Arqiva submission to Ofcom's consultation, *Revisions to Digital Radio Technical Codes*

Figure B.2: Testing arrangement for out-of-band emissions

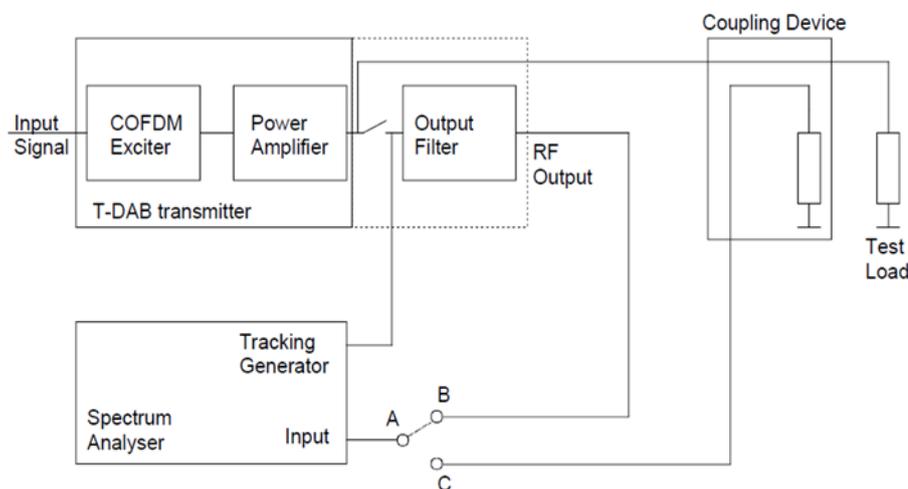
Paragraph 2.5c(i): In order to overcome dynamic range limitations of typical spectrum analysers, we propose a composite measurement approach. Arqiva recommends the methodology described in ETSI EN 302_077 V2.1.0 Annex B1.2

The composite measurement approach enables the user to effectively increase the dynamic range of the spectrum range (from typically >60dBc) to a figure equal to that of the analyser and filter combined- typically > 100dB (dependent on filter depth). This is set out below:

To overcome dynamic range limitations of typical spectrum analysers a composite measurement approach is proposed as follows:

- NOTE 1: Disconnect the power amplifier from the output filter.
- NOTE 2: The frequency response of the output filter shall be measured and recorded (connection A to B).
- NOTE 3: The spectrum of the DAB signal at the output of the power amplifier shall be measured and recorded (connection A to C).
- NOTE 4: The out-of-band spectrum of the DAB signal shall be calculated by applying the recorded frequency response of the output filter to the recorded spectrum of the DAB signal.
- NOTE 5: If the transmitter does not include any output filter, an external filter shall be added after the transmitter for the testing arrangement. This filter shall be representative of the RF combiner or filter existing in operational conditions and viewed by the transmitted output when installed. In this case, the antenna port measurements shall be performed at the output of this extra filter.
